Addendum #2

RE: QUESTIONS & ANSWERS, SPECIFICATIONS, DRAWINGS AND DOCUMENTS

Project
SICKKIDS - 7A SCHEDULE - 1BEDS REFRESH
ATRIUM (SLAUGHT) WING, 170 ELIZABETH STREET, TORONTO, ON, M5G 1E8

2 POWER & SYSTEMS - 7TH FLOOR PARTIAL PLAN - NEW WORK
SCALE: 1:50

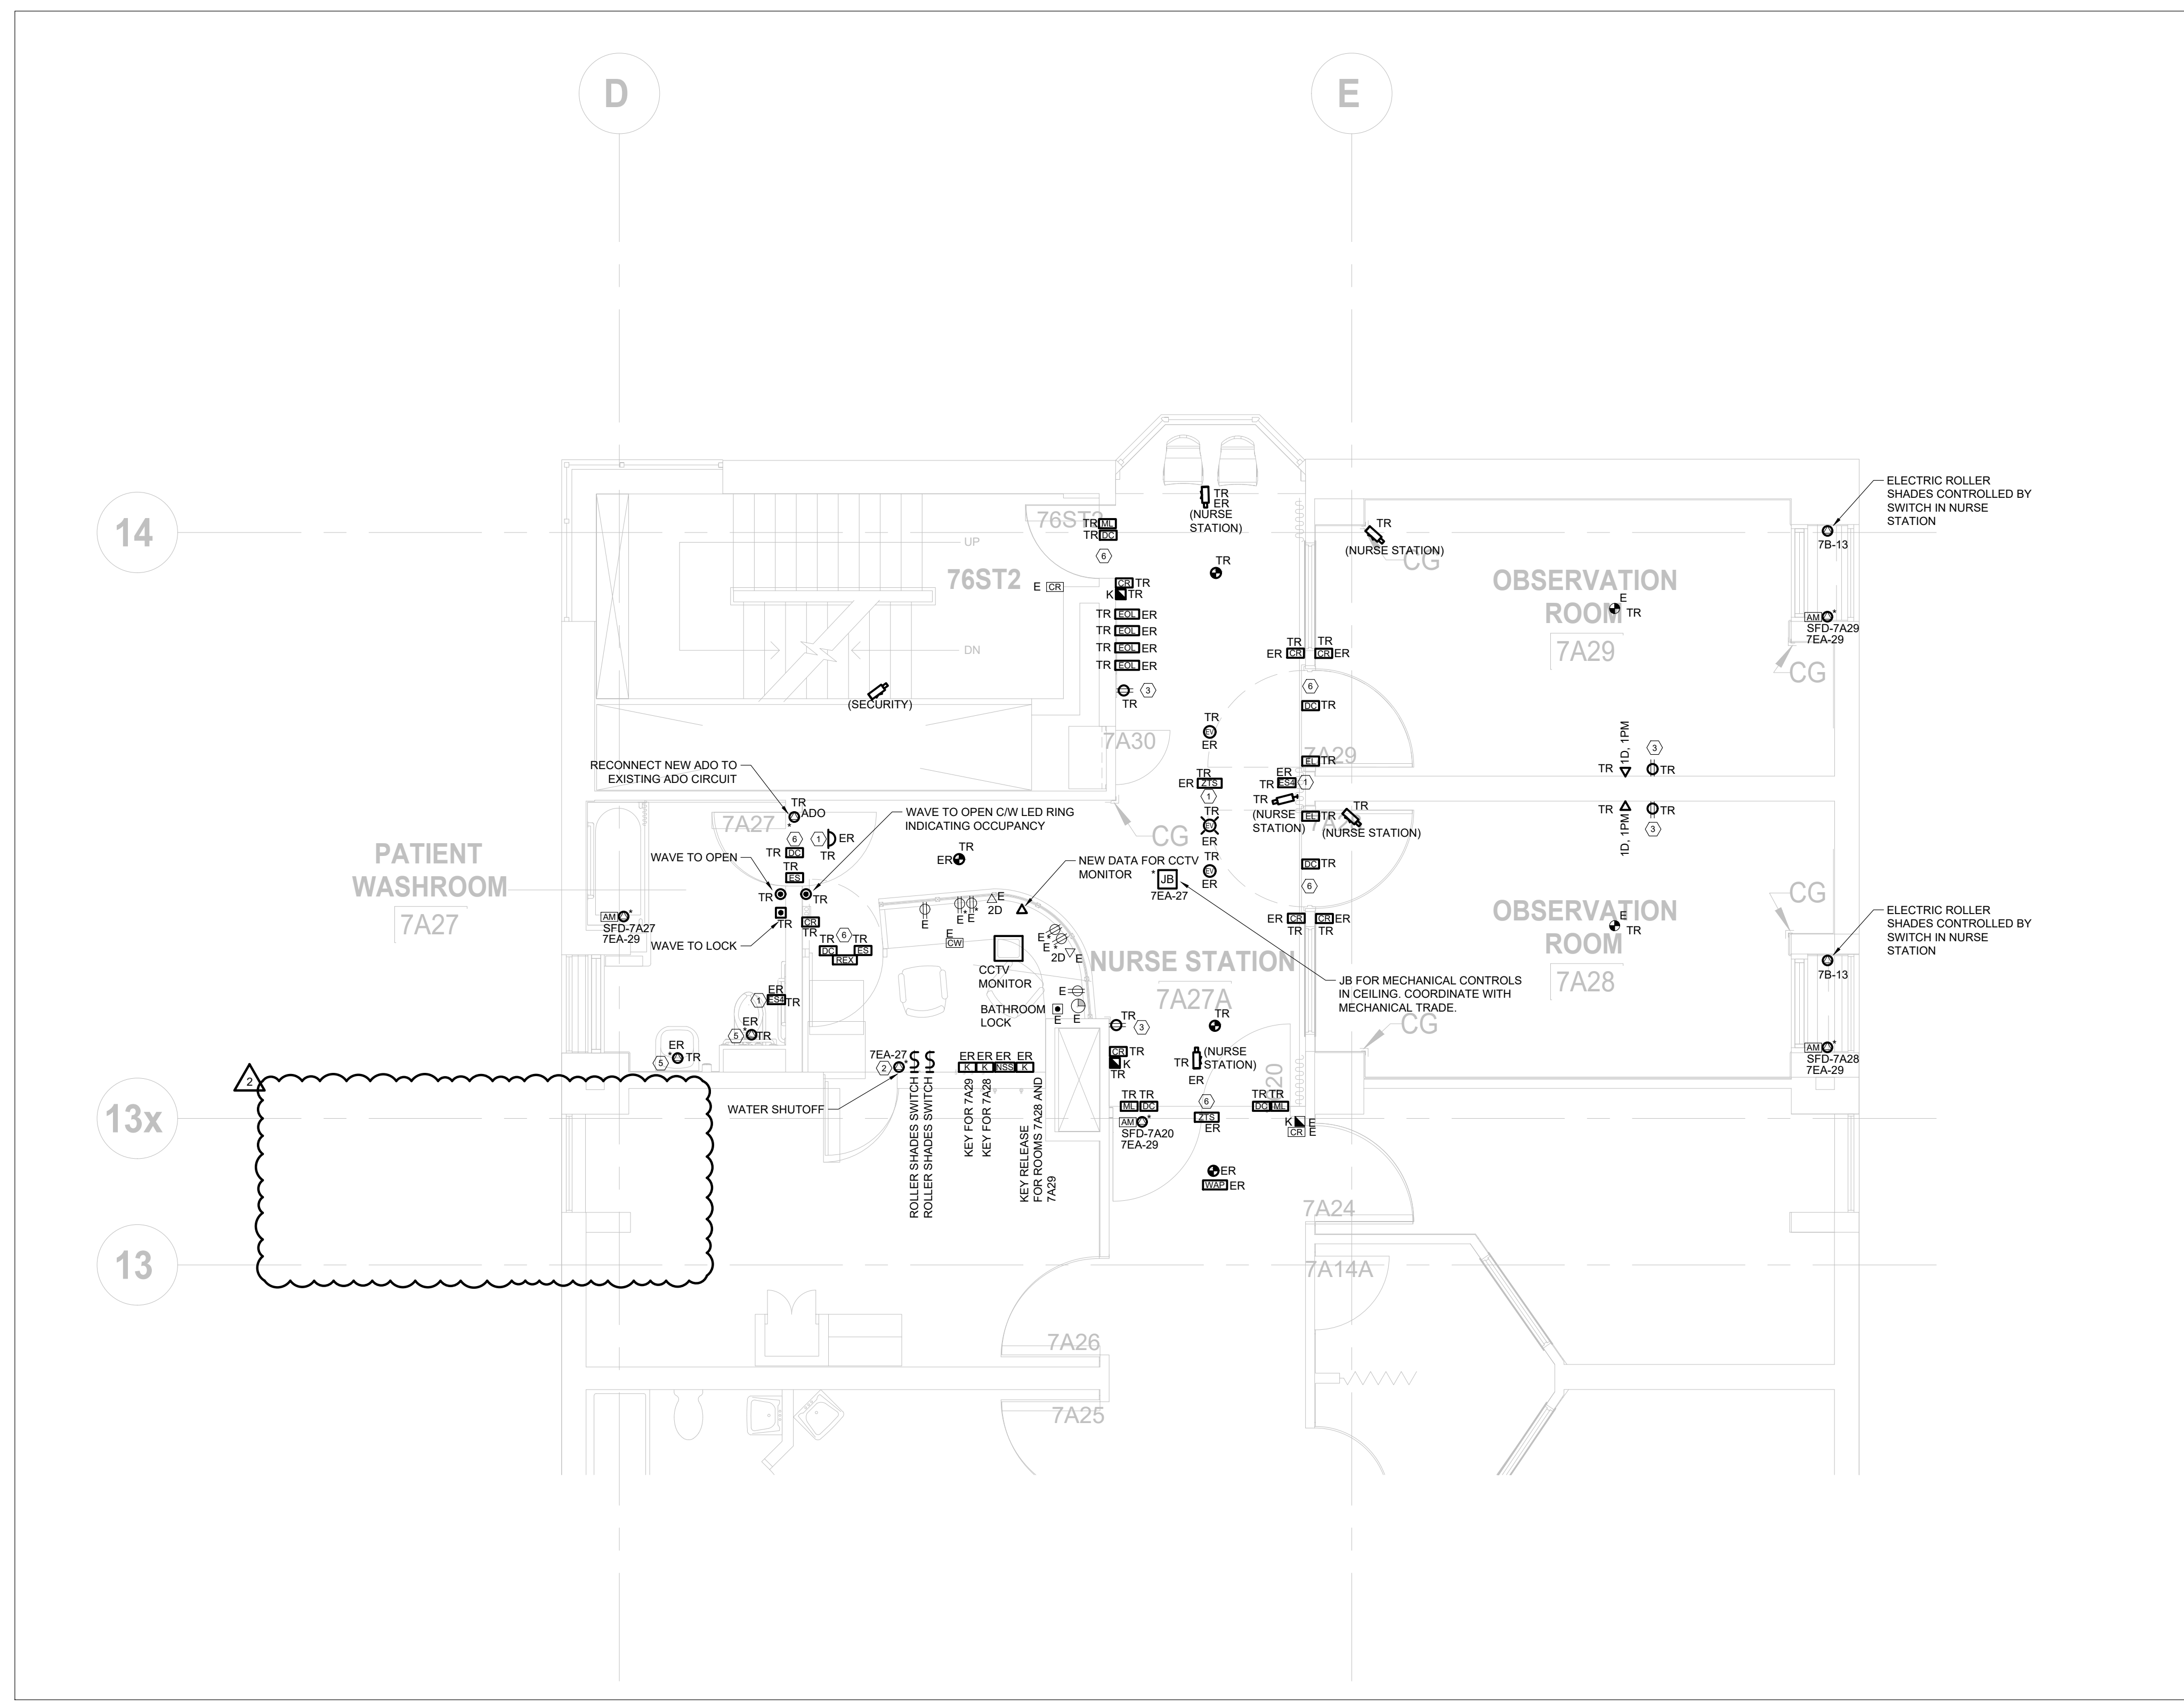
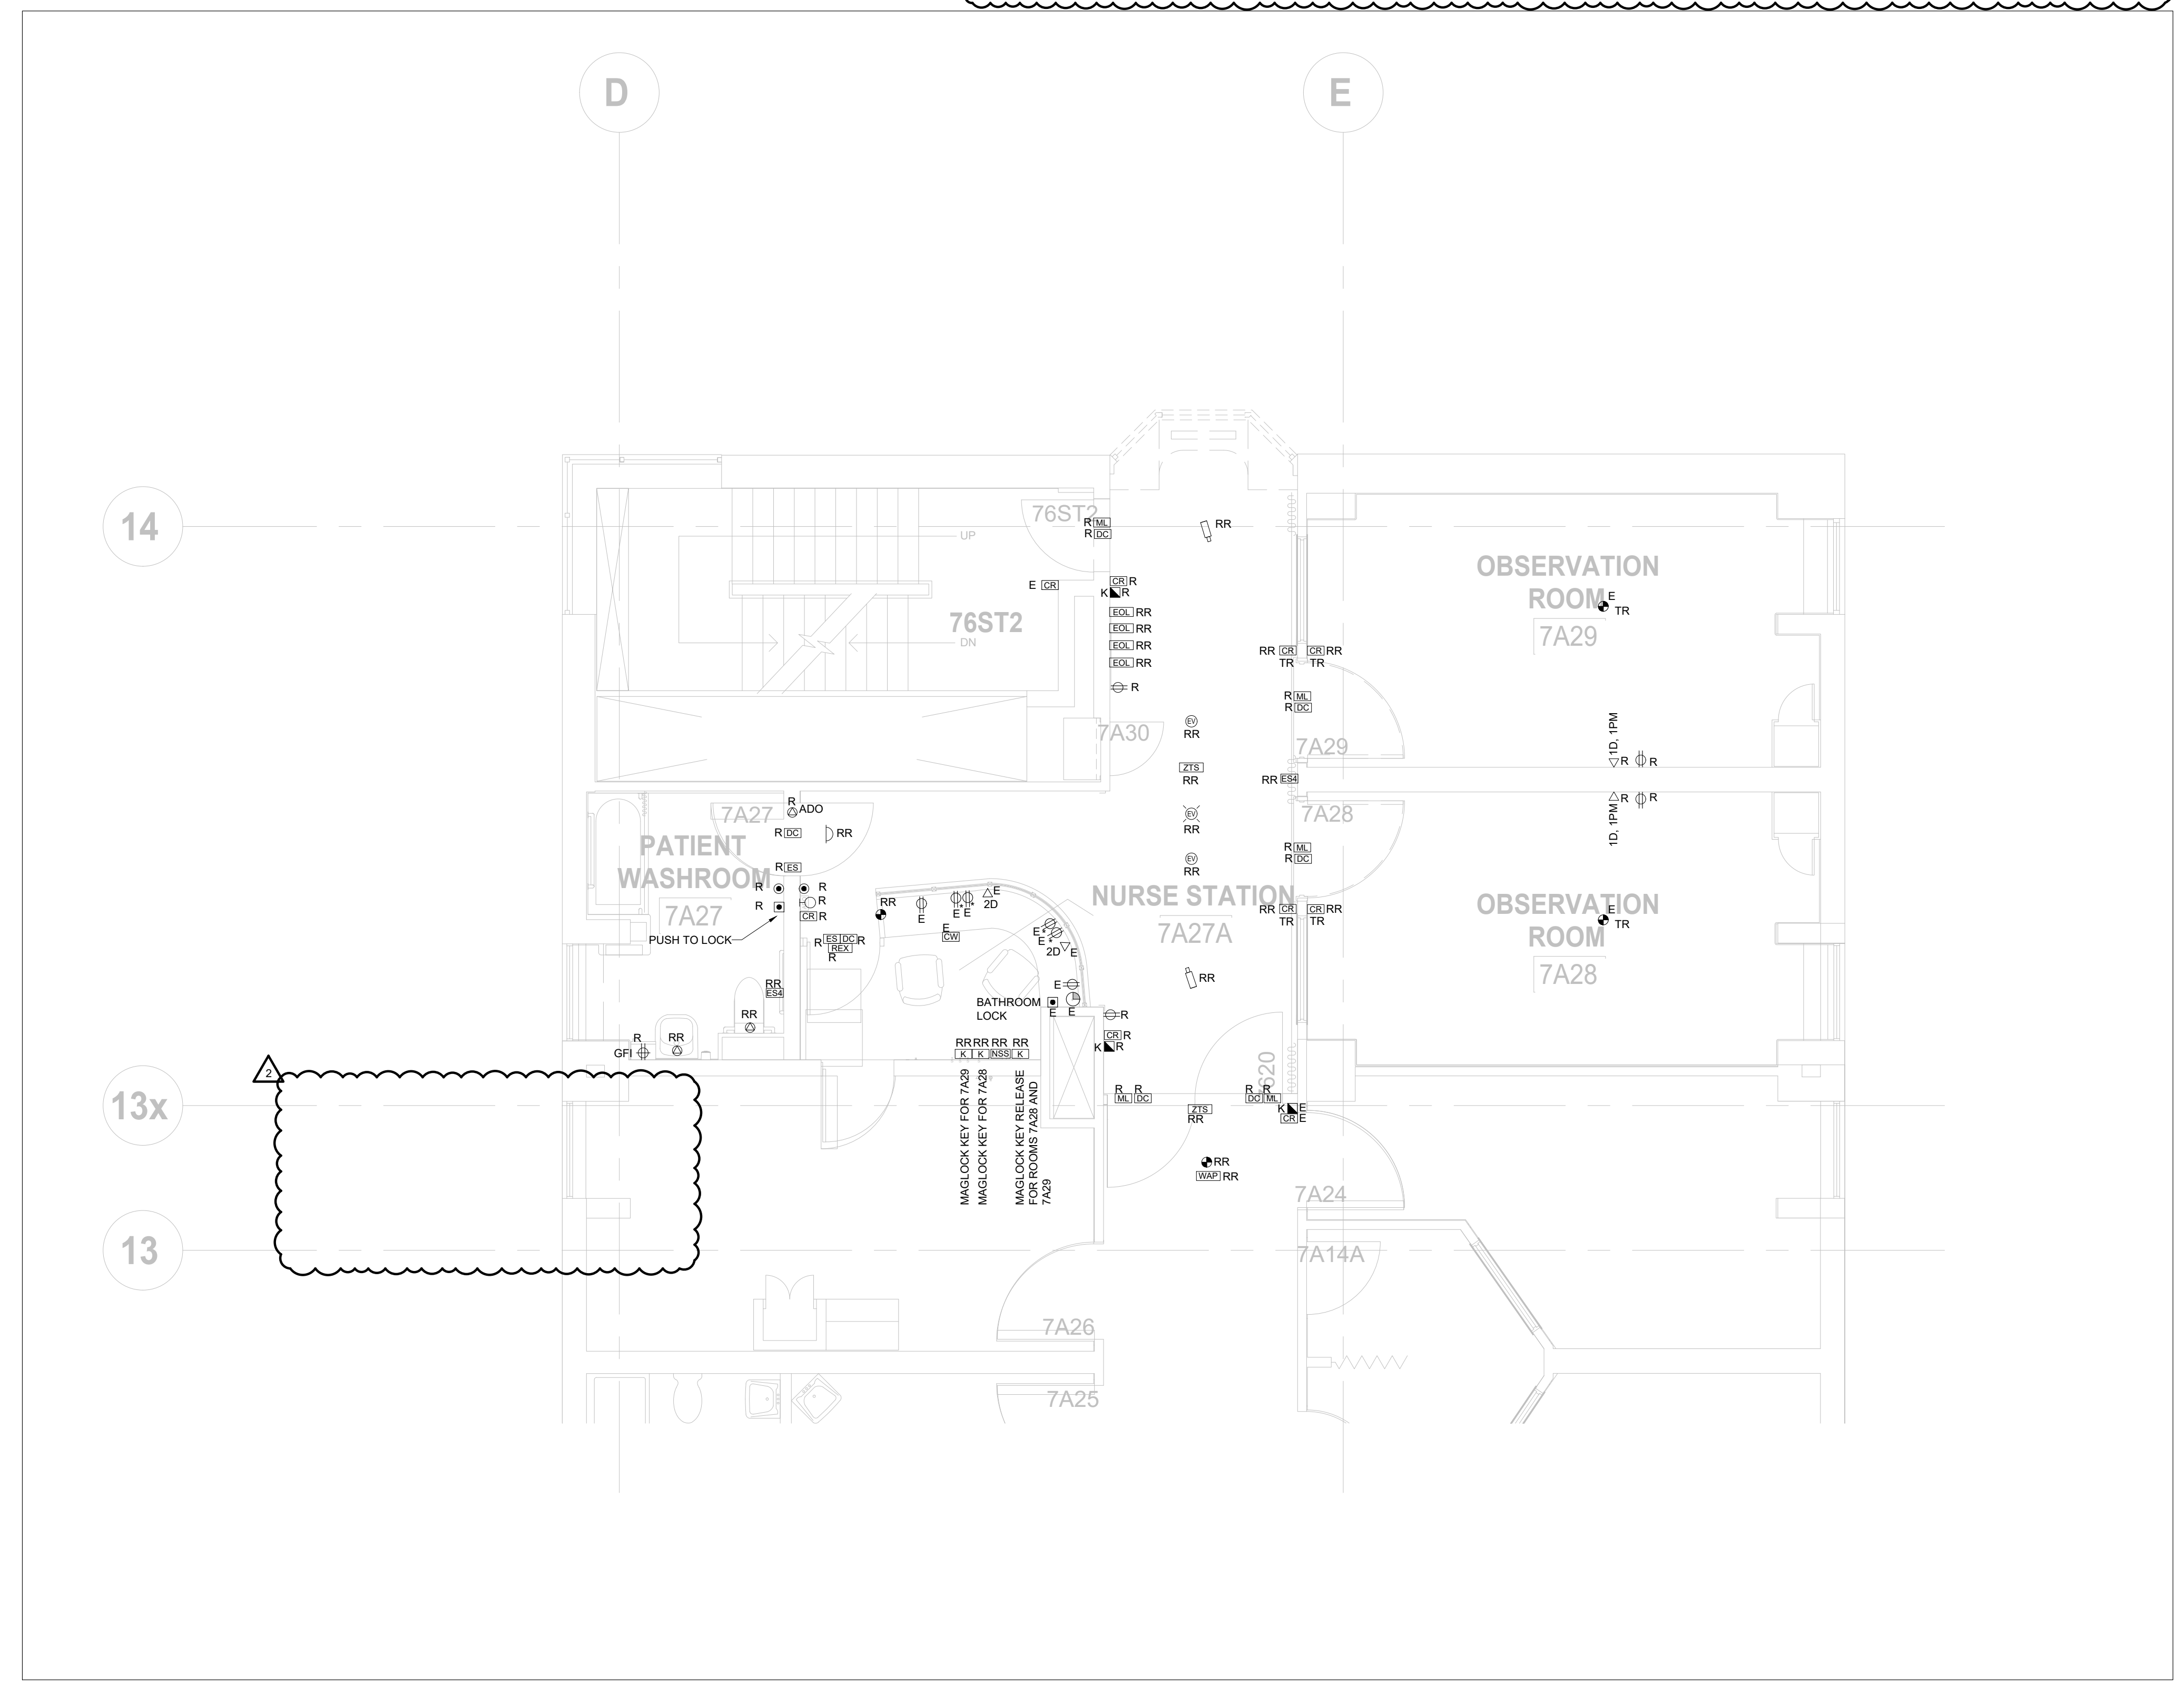
Q25- On drwg EP 07 AN 01 detail #2, confirm the 2 switches for the roller shades should be 1P 2T in order for the shades to go up down, also are the shades 120v, is there a wiring schematic?

Q26- On the same drwg & detail are the 4 fire dampers 120v, is there a wiring schematic?

Q27- On the same drwg & detail can we get a wiring schematic for the water shut off or are we just supplying & installing the 120v feeder?

Q29- On drwg EP 07 AN 01 detail #2 there is a monitor & 7 cameras, 5 indicate Nurses Station & 2 Security, can we get a wiring schematic of this?

Q30 On drwg EP 07 AN 01 detail #2 there are 3 x pull stations with a “K” beside them, what does this represent as I don’t see it on drwg EA 07 AN 02 Electrical Legend?

Q31- On drwg EP 07 AN 01 detail #2 there are 4 x FSD “AM” in a box c/w a direct connection to an emergency circuit, is this the same item “FSD” as indicated on drwg ED 01 detail #4 Fire Alarm Wiring Diagram, can we get a wiring schematic?

A25- Arch to specify, selection and electrical connections will be added as part of upcoming Addendum.

A26- Refer to sequence of operation on M&E plans, coordinate with FA (JCI/Tyco).

A27- 120V by electrical, LV by mechanical, refer to M&E drawings, mechanical drawings show wiring schematic.

A29- Clarification will be added as part of Addendum.

A31- Confirmed, refer to sequence of operation on M&E plans, coordinate with FA (JCI/Tyco).
